Port Layer Working Draft from SAS r00c rev 0

T10 02 2021r1 SAS Port Control State Diagram Update

Figure 2. Port layer PL_C state machine

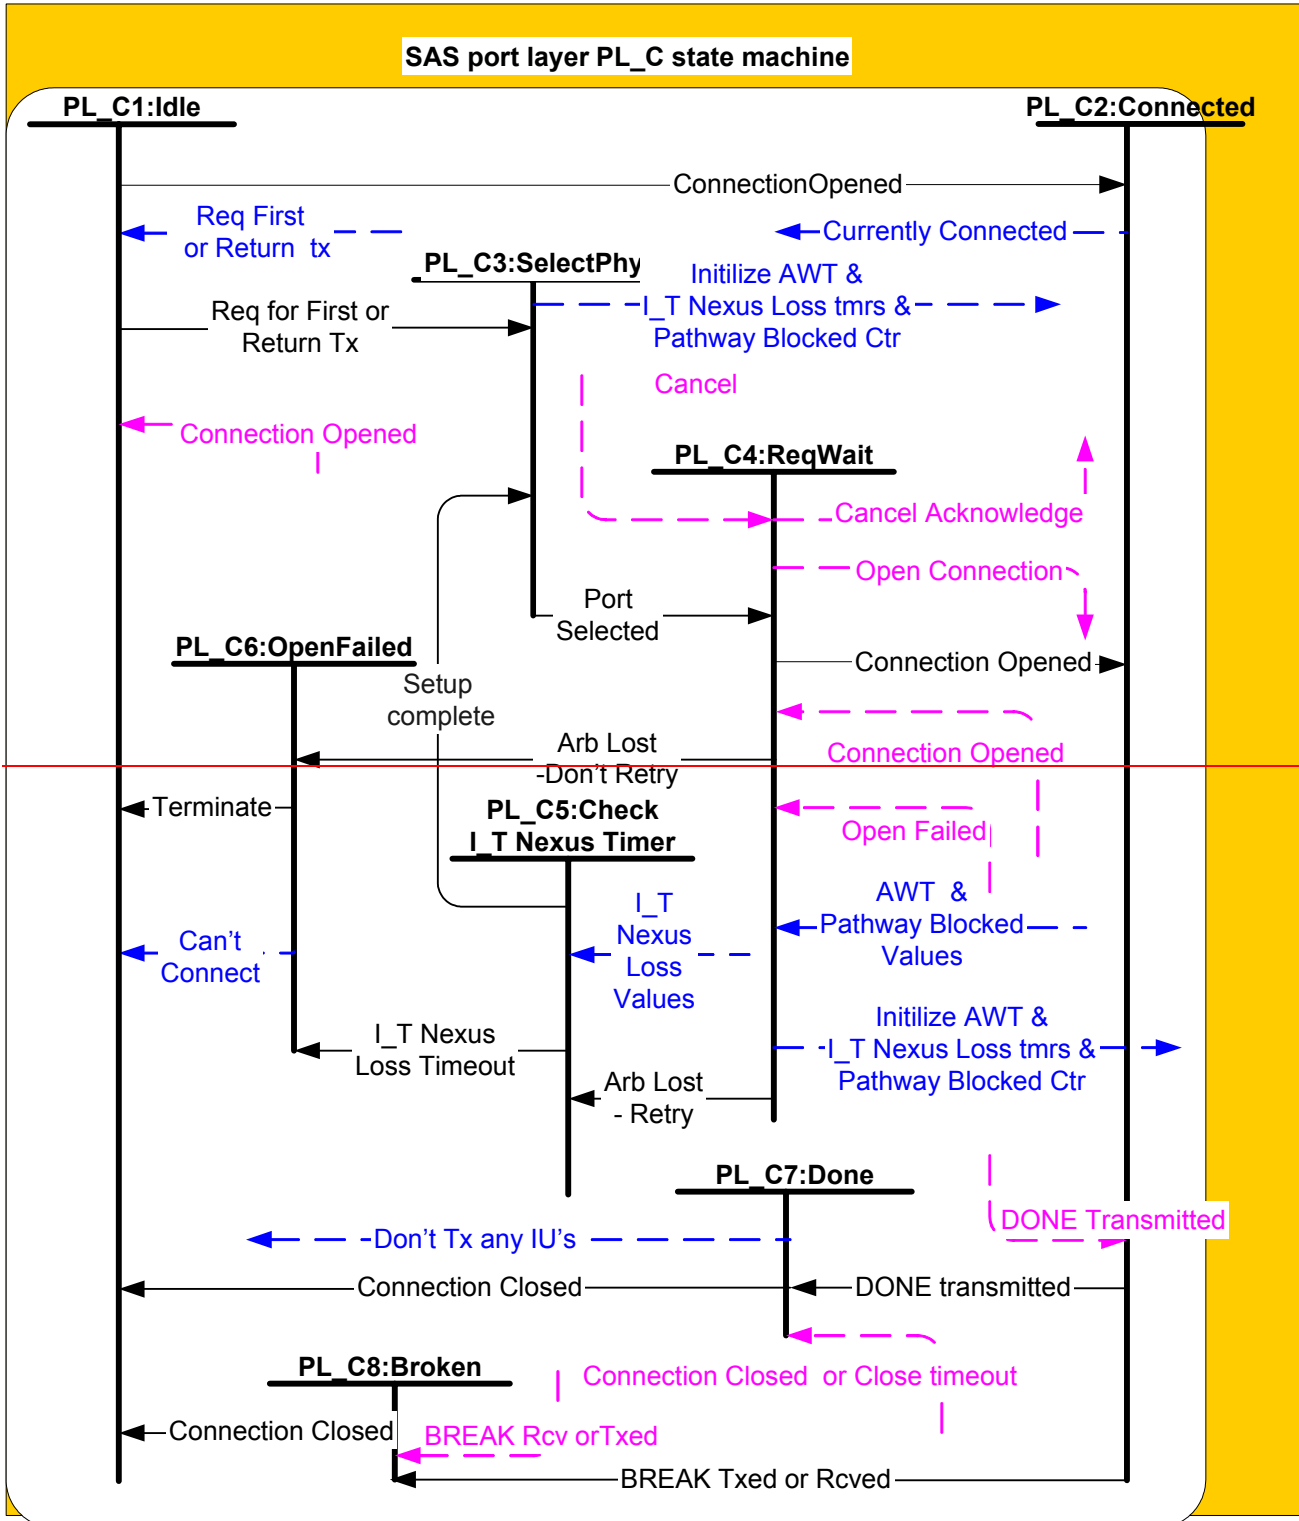
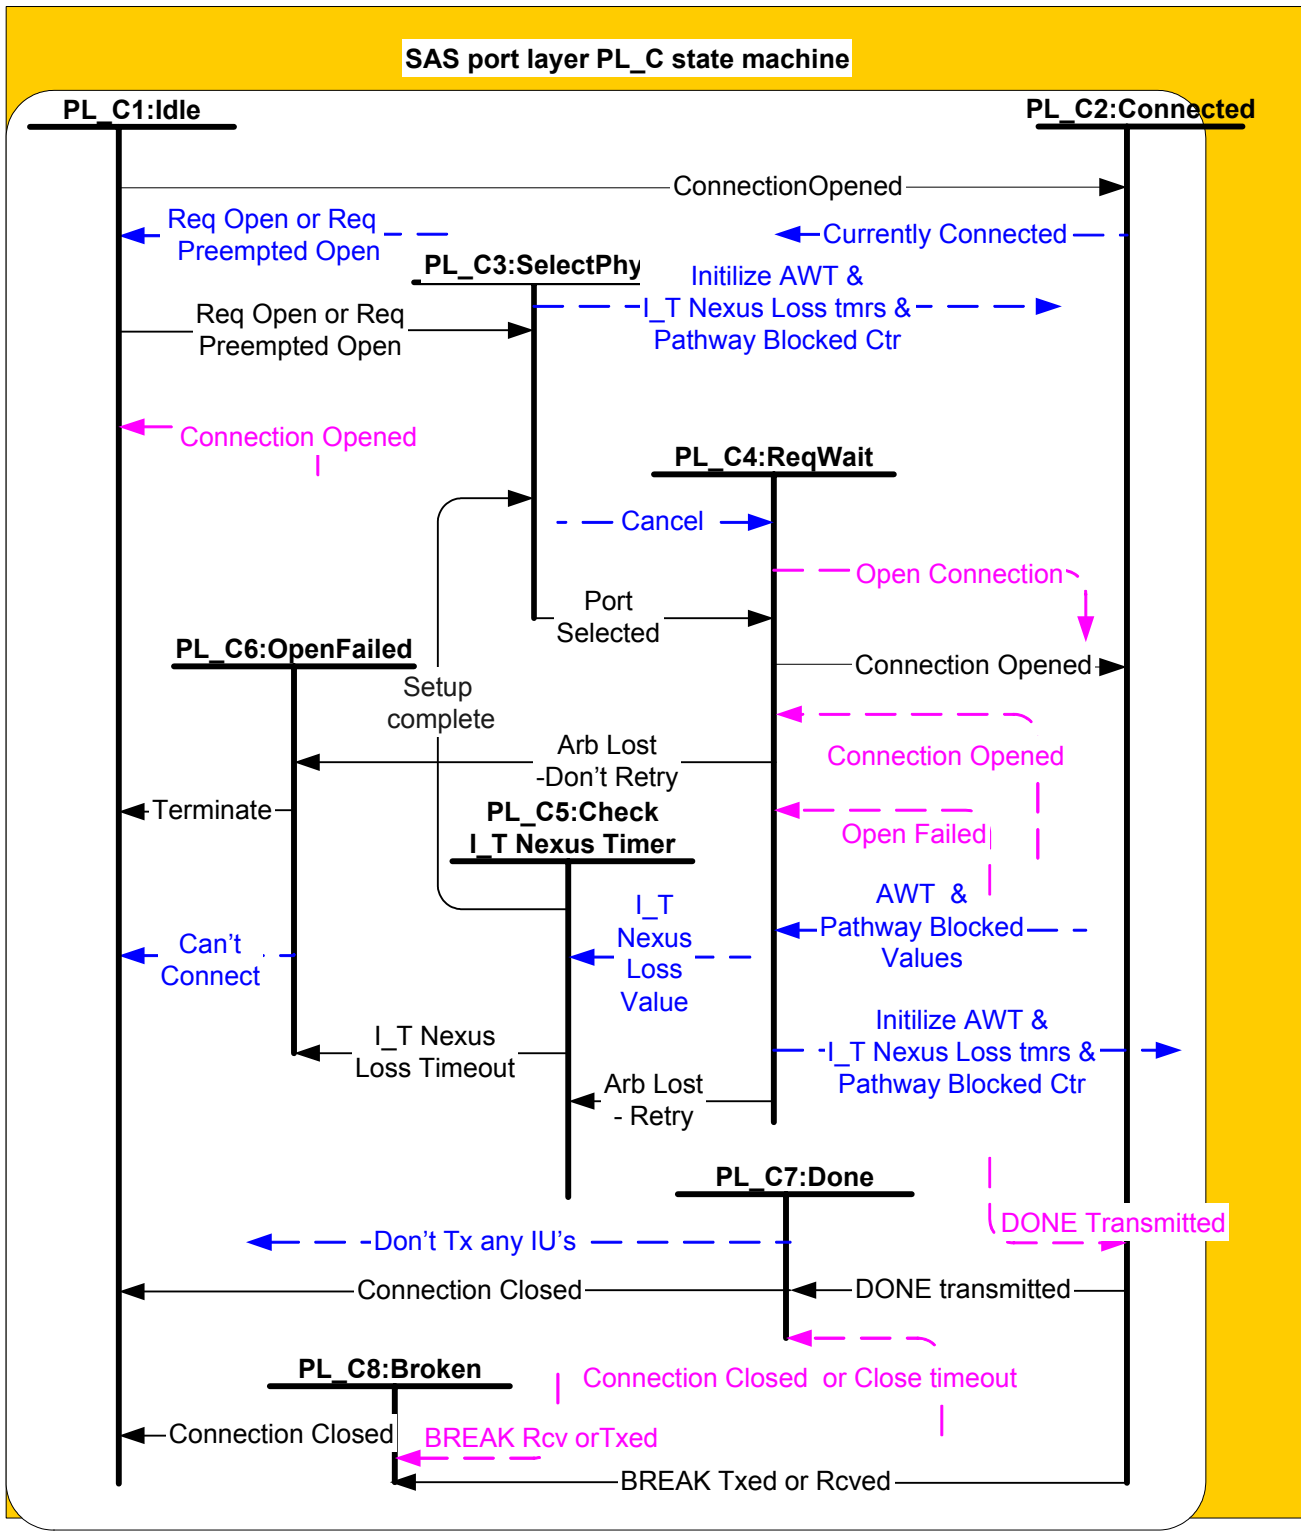
The PL_C state machine contains these states:

- a) PL_C1:Idle;
- b) PL_C2:Connected;
- c) PL_C3:~~ReqWait~~ SelectPhy;
- d) PL_C4:~~SelectPhy~~ ReqWait;
- e) PL_C5:Check I_T Nexus Timer;
- f) PL_C6:OpenFailed;
- g) PL_C7:Done;
- h) PL_C8:~~CloseWait~~ Broken;
- ~~i)PL_C9:Broken.~~

Figure 3. Port layer PL_RQ_OC, PL_TMR, PL_T, and PL_R state machines

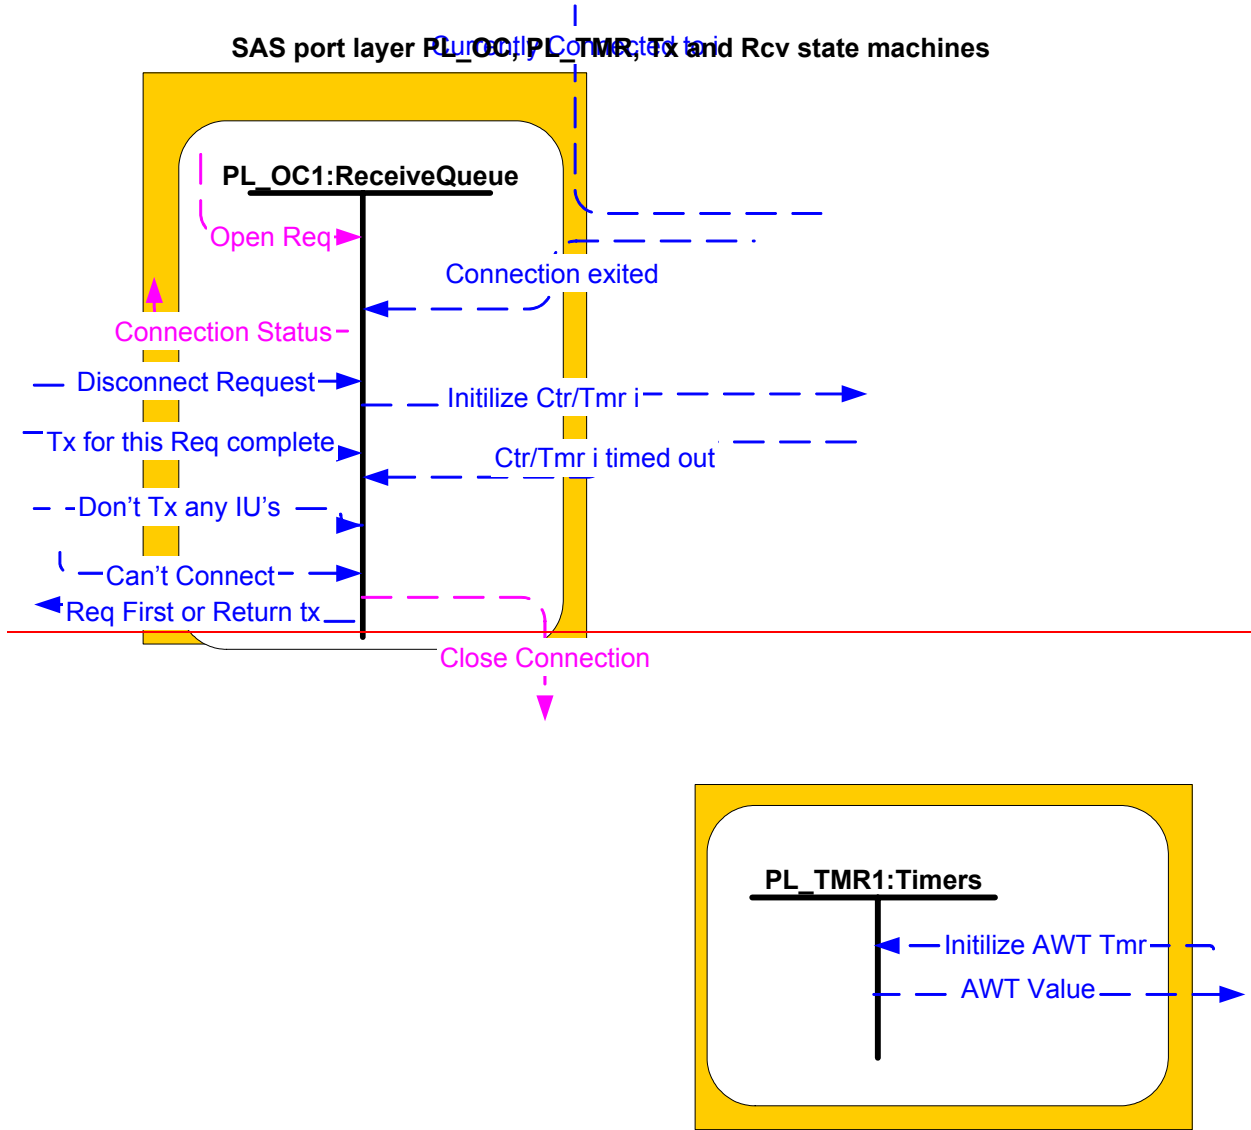
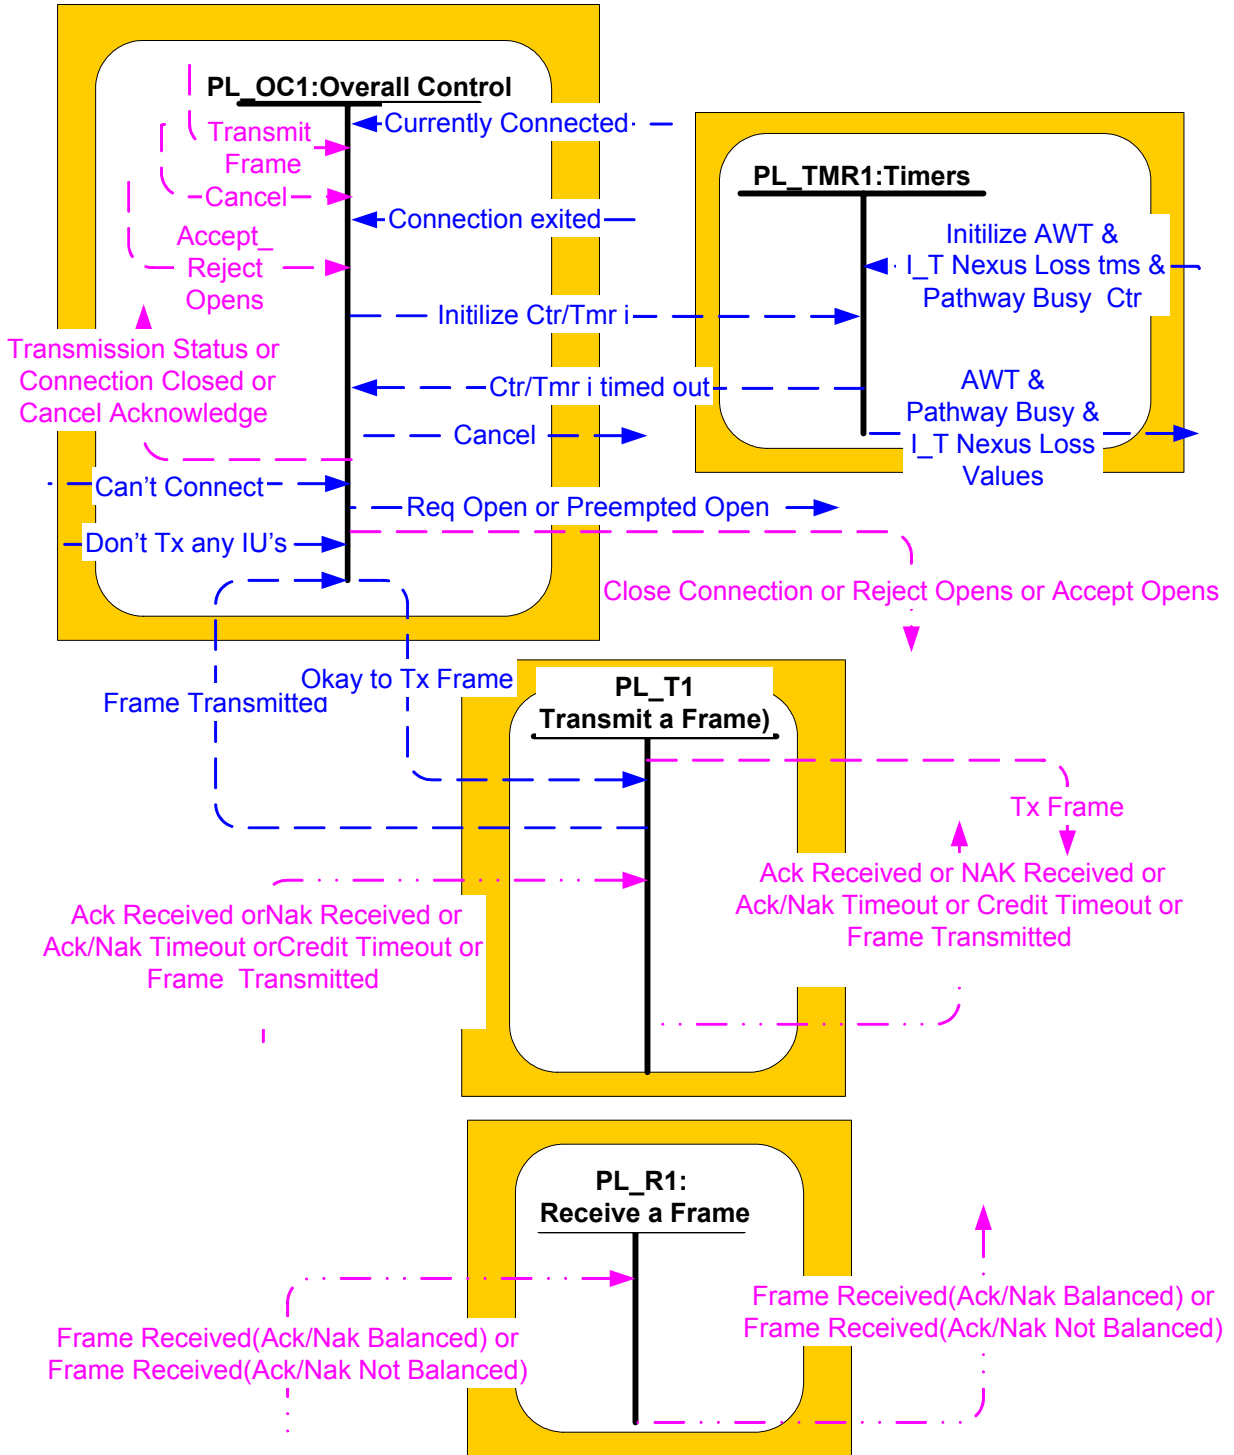
~~Three-Five~~ state machines ~~that~~ run in parallel to form the port layer.

- ~~Receive and queue connection requests~~ Overall Control (PL_RQ-PL_OC state machine);
- Counters and ~~t~~imers (PL_TMR state machine); ~~and~~
- ~~Control-Connection~~ (PL_C state machine);
- Transmit a Frame (PL_T state machine); ~~and~~
- Receive a Frame (PL_R state machine).

Figure 3 shows the PL_~~RQ~~OC, PL_TMR, PL_T, and PL_~~TMR~~ state machines.
